Series resistor and Zener as overvoltage protection for ADC input

I am trying to come up with a simple overvoltage protection circuit for a Teensy's ADC inputs, which can only handle voltages between 0-3.3V. I am studying EE in college, but I haven't yet done much with Zener diodes and would appreciate any feedback.

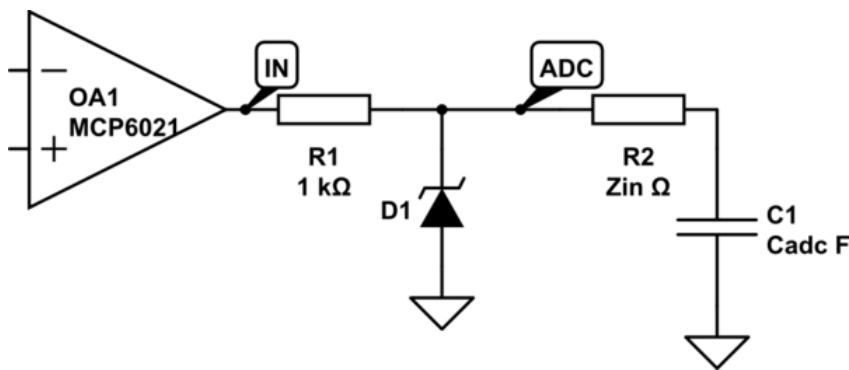
Even if your opamp has a maximum of 23mA drive this doesn't mean he's happy to be essentially shorted to ground (some amps are designed with limiting circuits but that's not the norm). In fact the MCP600x says that the *absolute maximum* is 30mA. The 23mA figure probably comes from the typical output impedance of the output stage.

If you decided instead to let the opamp suffer (could be a dubious choice however), 3.3V over 30mA is 100mW so probably the zener could dissipate it (too many disadvantages however!).

There are two other issues to consider: if you short the output, even if inherently limited by the amp output stage it will take some time to recover; something like the usual slew rate but slower since the output stage is completely out of its operating point (search for overload recovery for more info). So definitely you don't want it to happen (unless it's a very slow signal).

In short: your suggested 1k protection resistor (properly placed) *probably* is correct. Assuming the amp is powered at 5V the output current is limited to 1.7mA. You could go down to 180 ohm if you have power to spare and have 10mA on the zener.

FIGURE 23-5: ANALOG INPUT MODEL

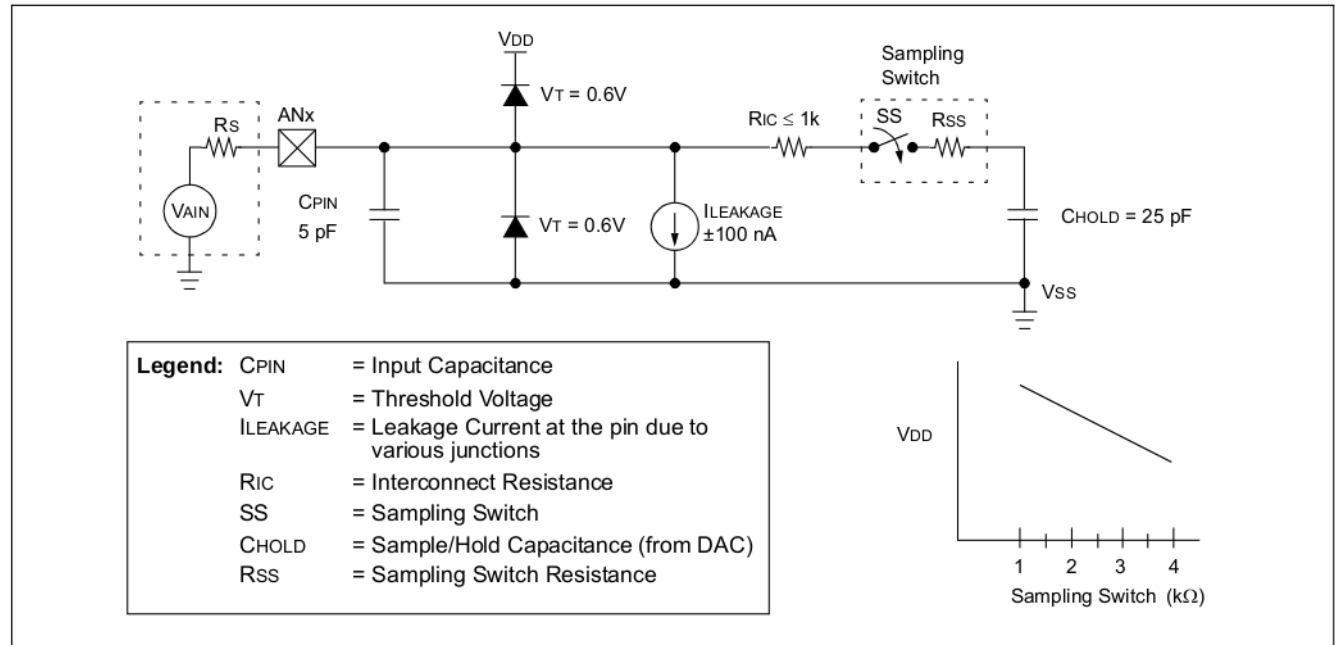
The V_{AIN} is your opamp while R_S is your protection resistor (the equivalent output impedance of the opamp when not overloaded can be assumed as zero due to feedback). Your zener diode actually adds some capacitance to ground (some pF) but you'll worry about that when you get to higher speed signals.

See that you have about 2-4kohm input resistance in the ADC due to multiplex circuitry and you need to charge a huge 25pF capacitor (as I said it's an old part, these days the sample capacitor is more like 5-10pF).

The source impedance affects the offset voltage at the analog input (due to pin leakage current). The maximum recommended impedance for analog sources is 2.5 kohm.

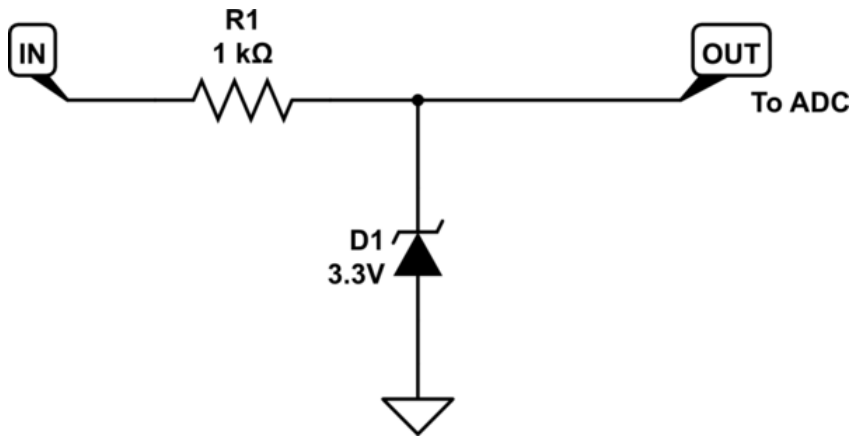
2 You want R1 inline with V_{in} – Big6 May 23, 2022 at 23:34

You are *partly* right. The resistor however is misplaced, it should go in series *before* of the zener.

As you have it, the circuit won't protect your ADC input. The voltage across the zener diode cannot exceed 3.3V, that much you've understood. But the voltage across the resistor can rise to any value.

In other words, the ADC input potential will be the sum of the voltages across R_1 and the diode, because they are in series. Since the voltage across R_1 is not constrained, neither is the voltage at the top of the diode!

In this circuit, D1 successfully constrains V_{OUT} . Think of it this way: we know that the voltage across D1 cannot exceed 3.3V, and since its anode (bottom) is held at 0V, its cathode is never permitted to rise above $0V + 3.3V = 3.3V$. Your version fails because you're *not* holding the diode's anode at 0V.

I think you meant something like this:

One of the purposes of R1 is to protect the diode. If the voltage source "IN" is low impedance, and connected directly to D1's cathode, when it tries to rise beyond 3.3V D1 becomes a very good conductor, and will carry a lot of current to ground in an attempt to keep its cathode *under* 3.3V. Somebody has to lose that fight.

To avoid the fight, we employ R1 to provide some "elasticity" between "IN", which insists on being 6V (for example) and "OUT" which the diode insists cannot be more than 3.3V.
